Coal Combustion Waste Impoundment

Round 7 - Dam Assessment Report

Walter Scott Junior Energy Center

MidAmerican Energy
Council Bluffs, Iowa

NUMBER INDICATES BLOCK ENCLOSED BY 1000 FOOT BASE LINE GRD. (PLANT COORDINATE SYSTEM)

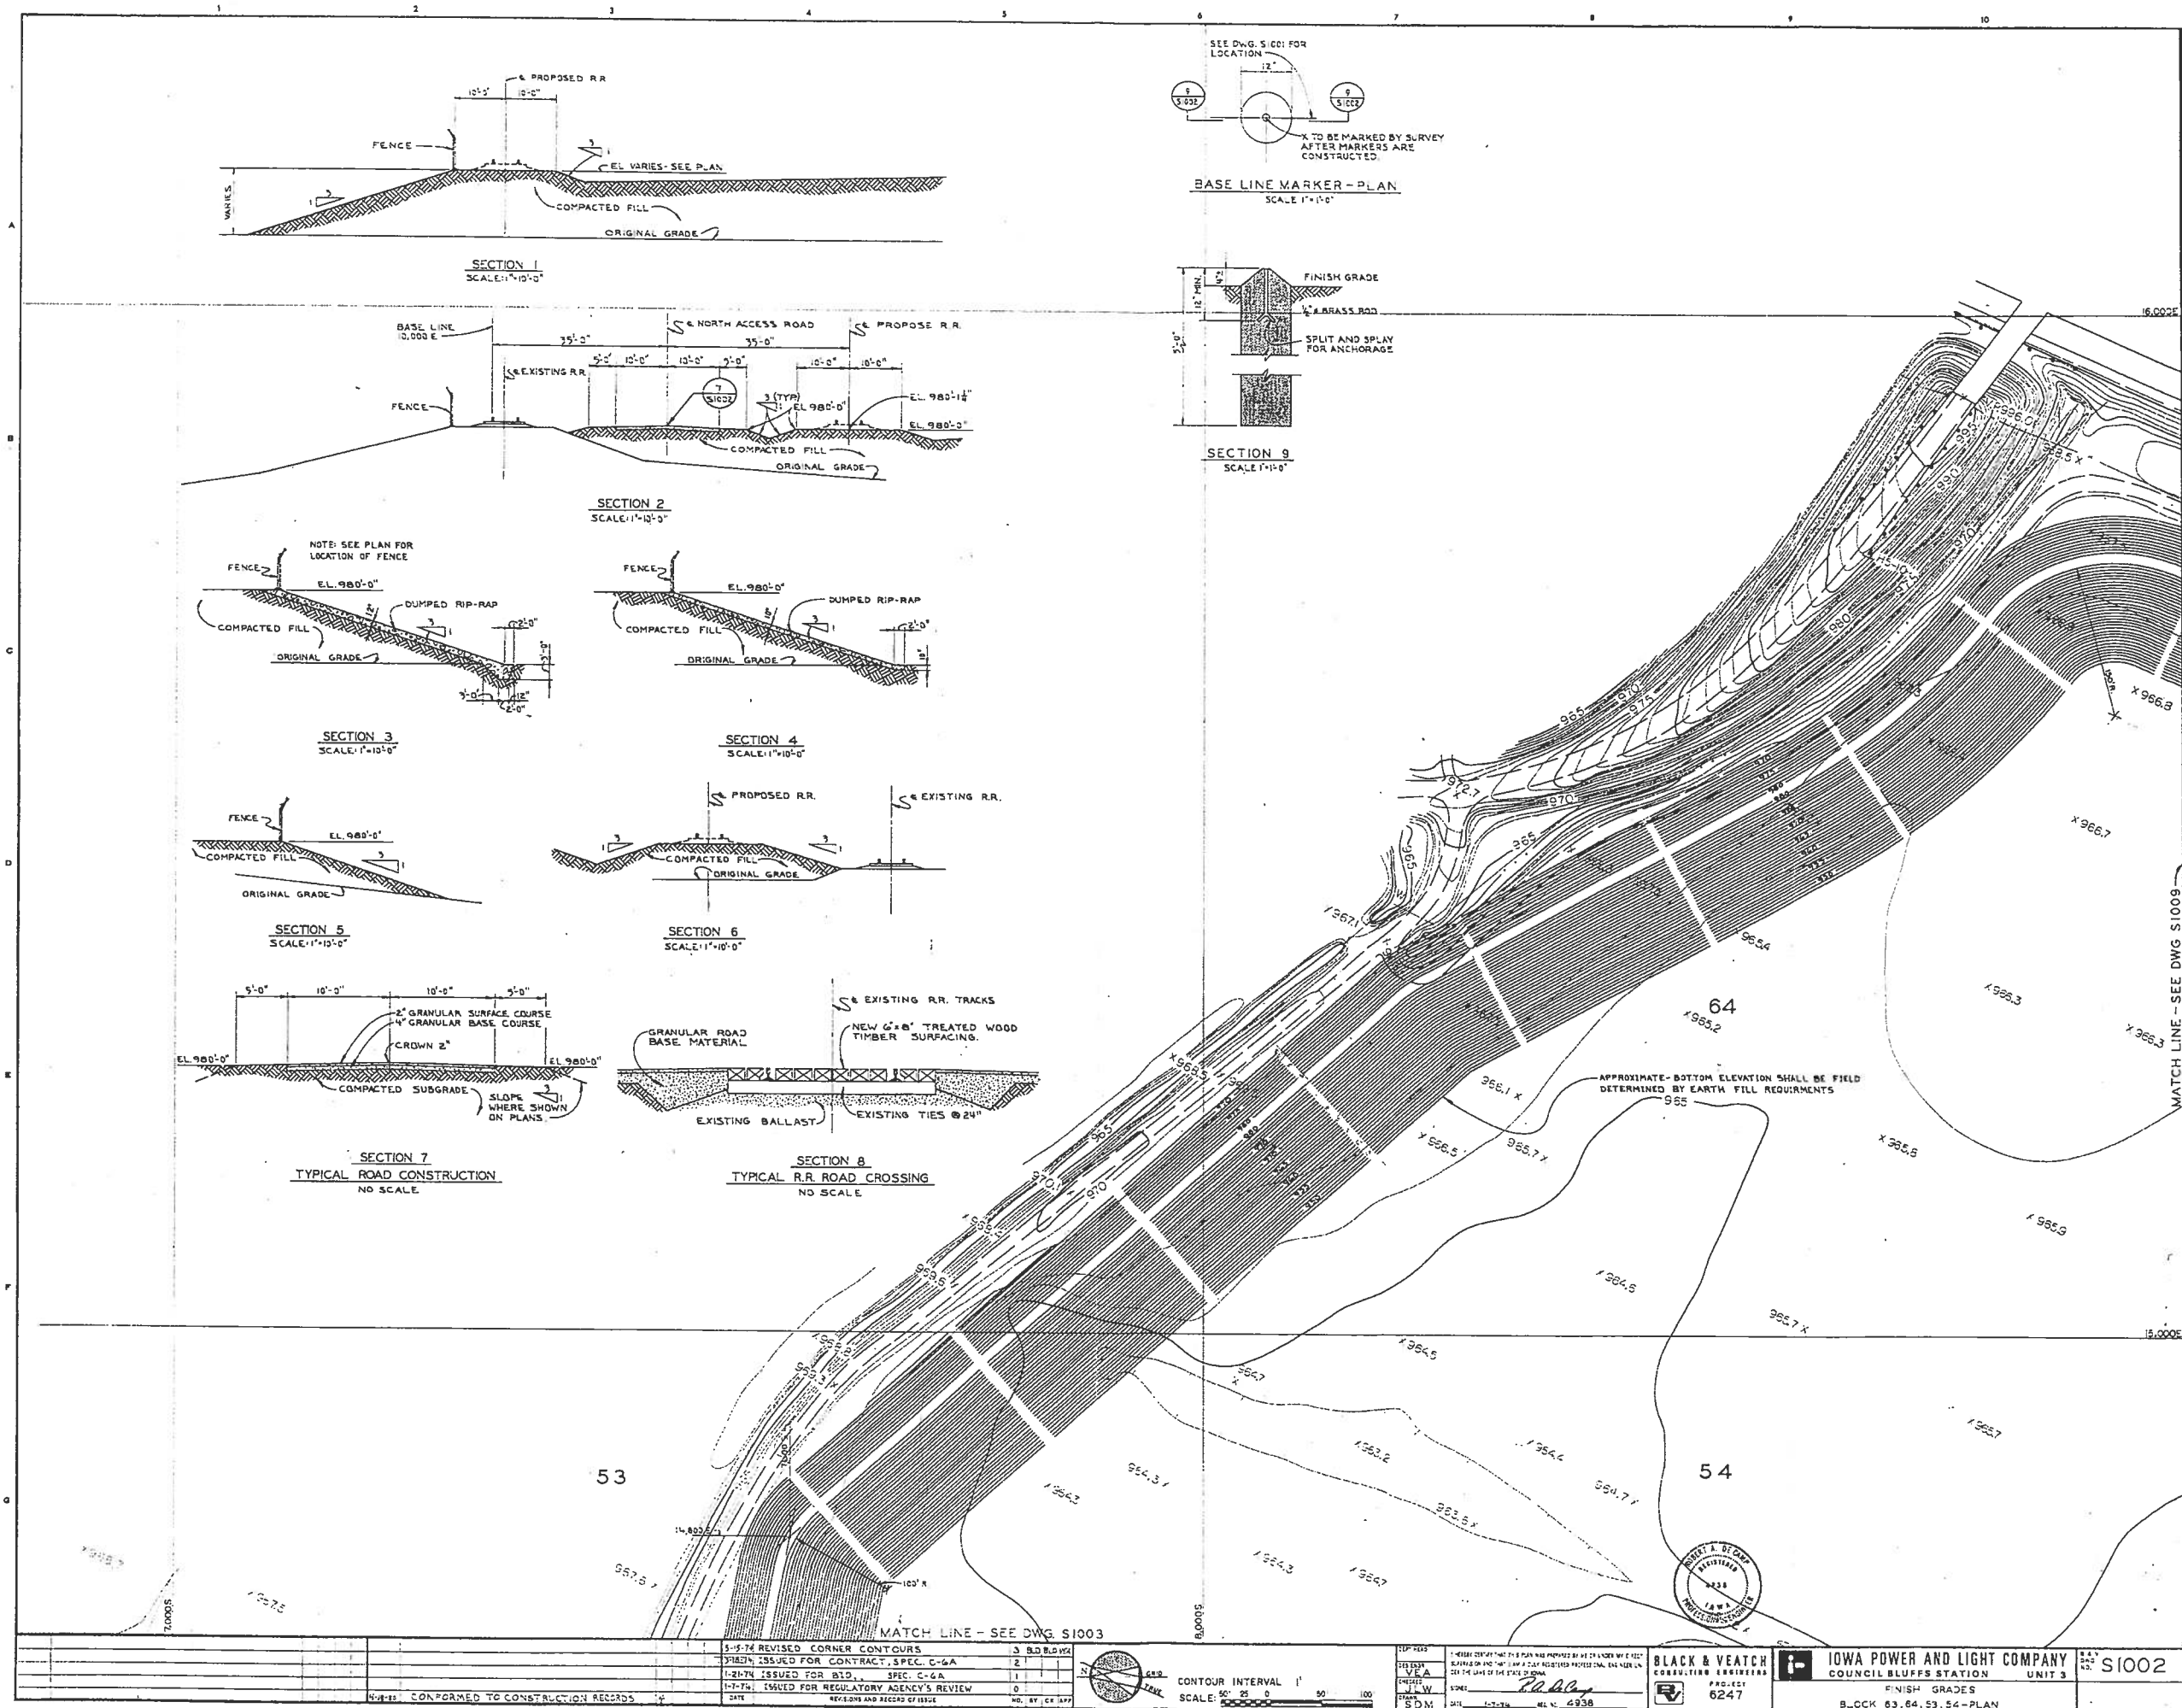
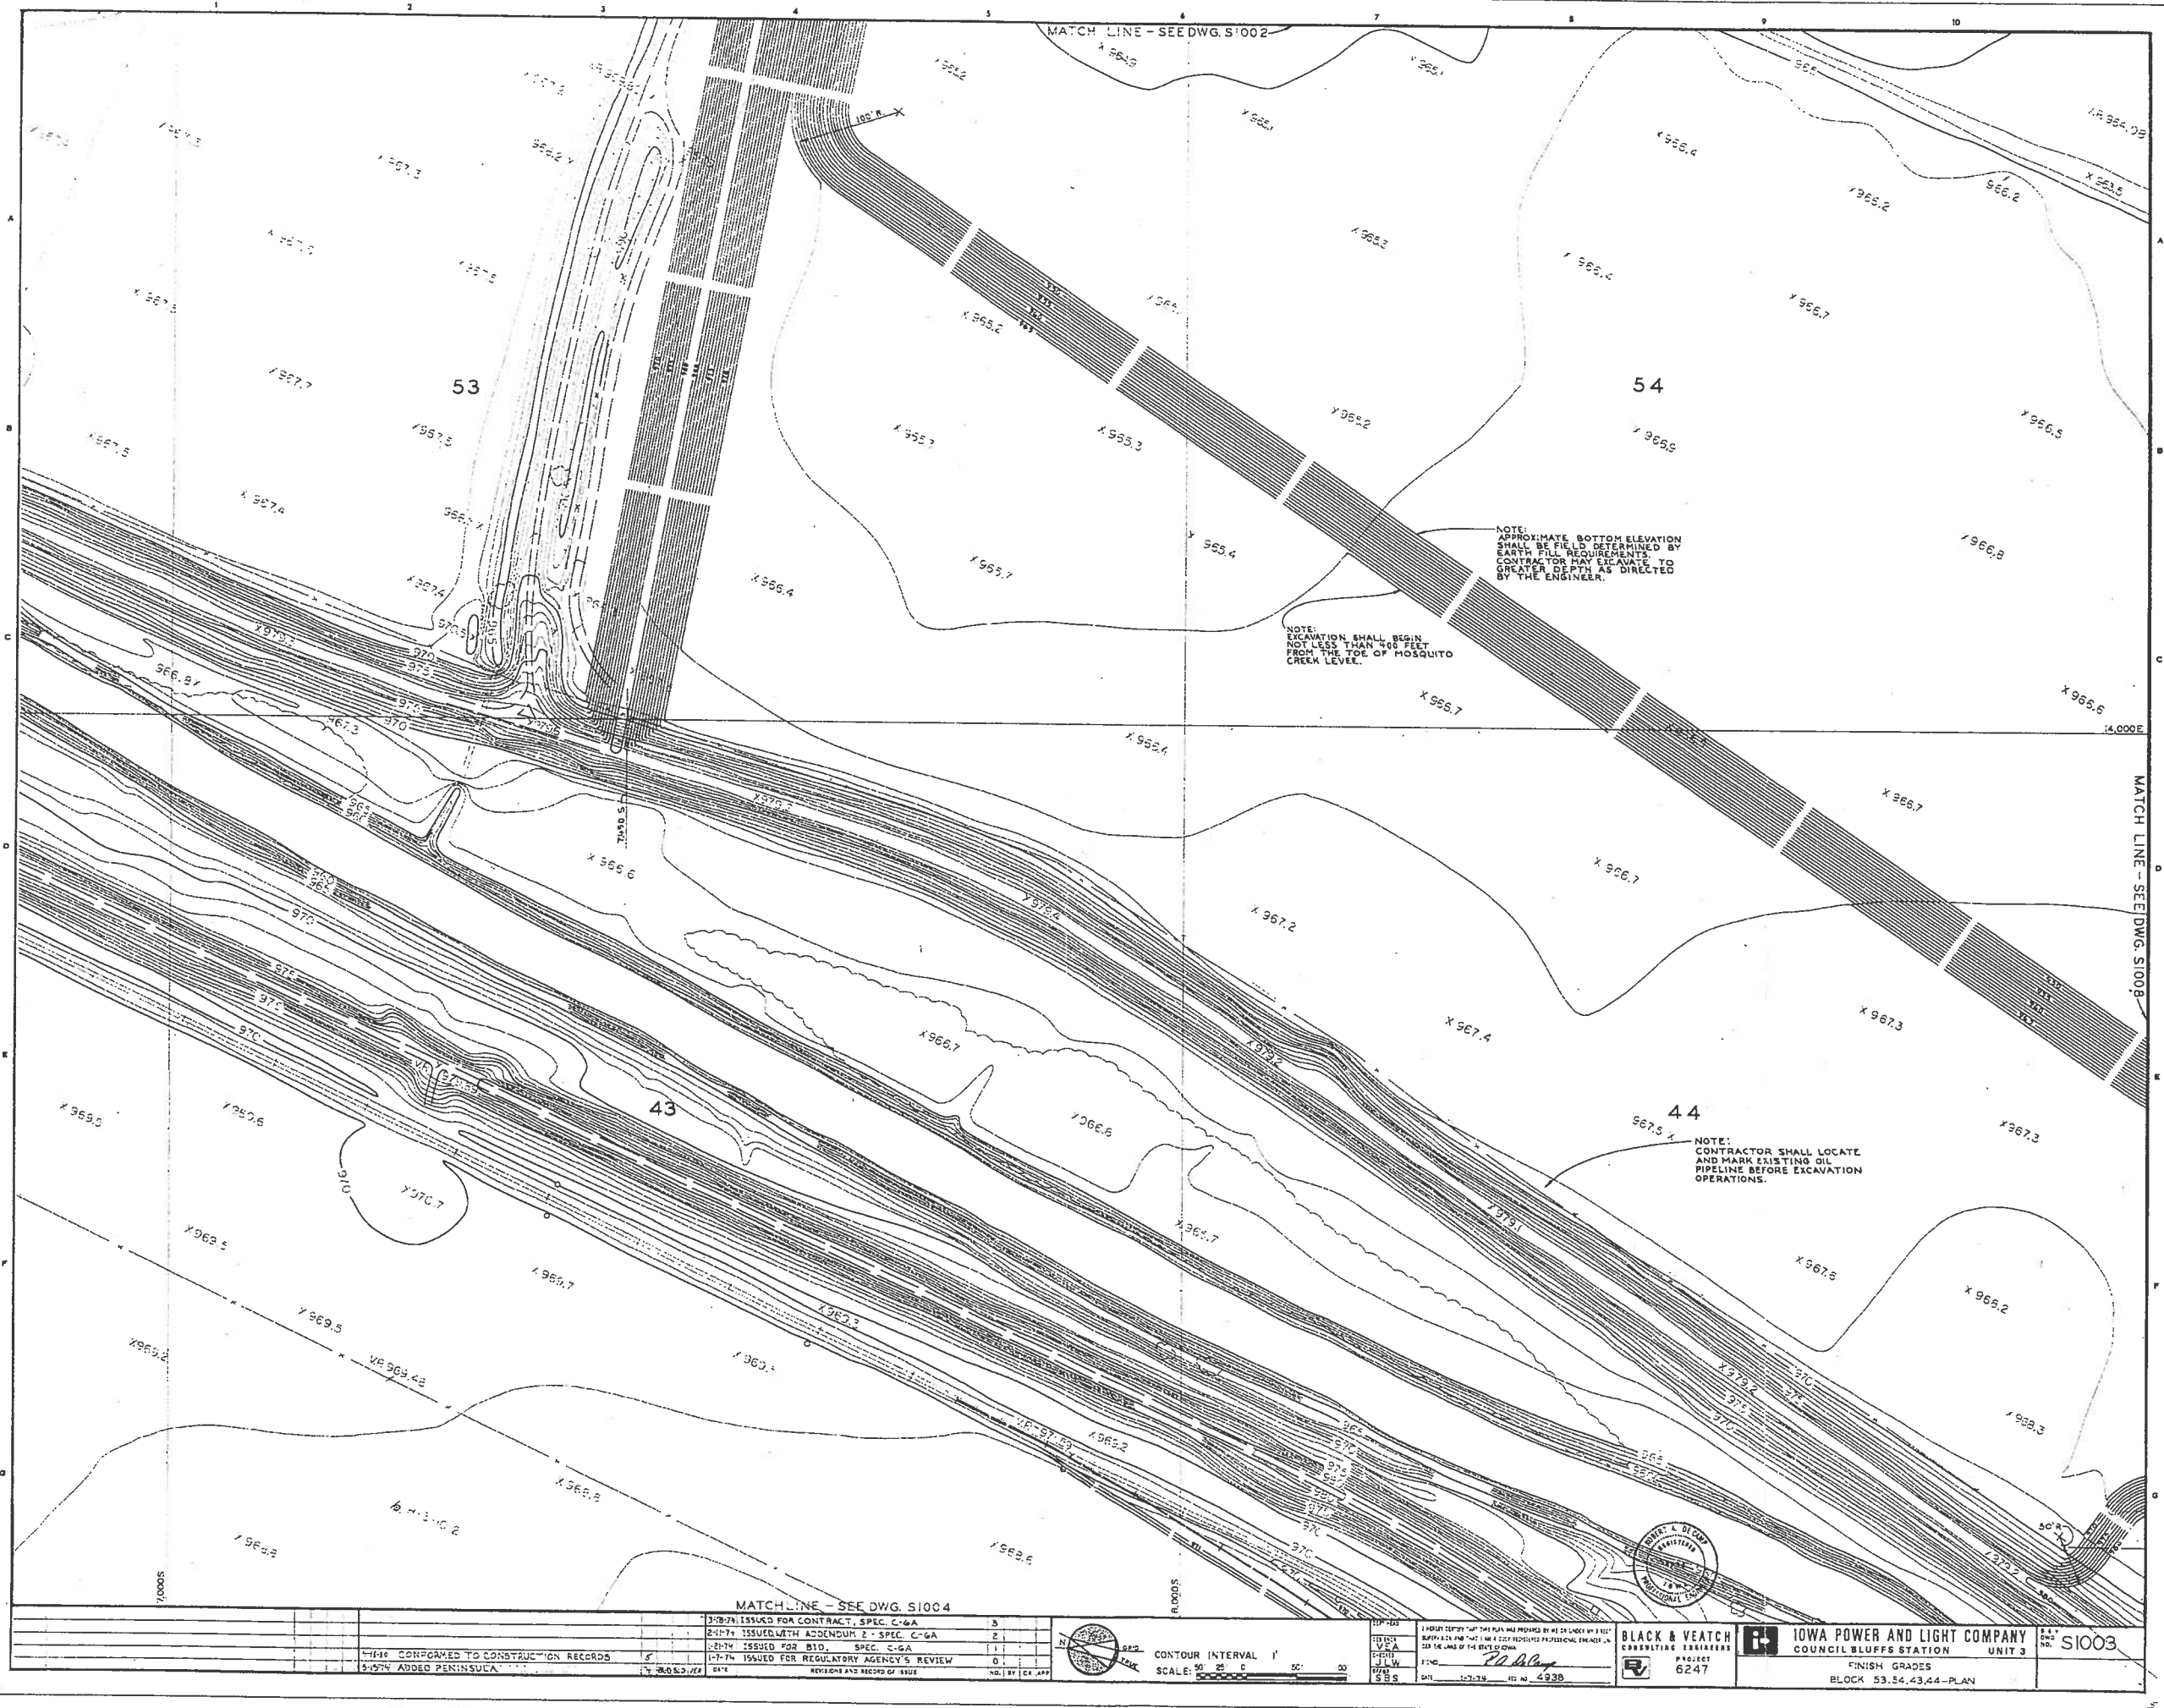
Supporting technical documents are generally adequate for the purposes of this review and assessment, although furnished drawings show original design features and do not reflect as-built features or all modifications that have been made since original construction (e.g., the SIRE railroad embankment built across the western part of the ash basins does not show on any of the furnished drawings).

Descriptions provided are generally sufficient. As noted above, furnished drawings do not show or note as-built features or all modifications that have been made since original construction.

horizontal (H) to 1 vertical (V) side slopes. The final design grades of the levees and dikes of the North Ash Pond are shown on the Finish Grades plans in Appendix C - Doc 1.3. However, the crest of the south side levee is actually about 3 feet higher than shown on the Finish Grade plans. MidAmerican indicated that the USACE raised the Mosquito Creek and Pony Creek levees in the early 1980s, and the change in height resulted in a slope of the crest from elevation 982 feet to 983 feet. However, a recent survey of crest elevations around the perimeter of the pond suggests that the Mosquito Creek levee was not raised (see Appendix D - Item 2).

Update project documents to include or note current features of the ash basins and modify or supplement the documents as needed when changes are made in the future. For example, the recently completed crest elevation profiles around both ash ponds surveyed by HGM Associates, Inc. (Appendix D - Item 2) serves to provide documentation of current crest elevations, which should be referenced on official project plans.
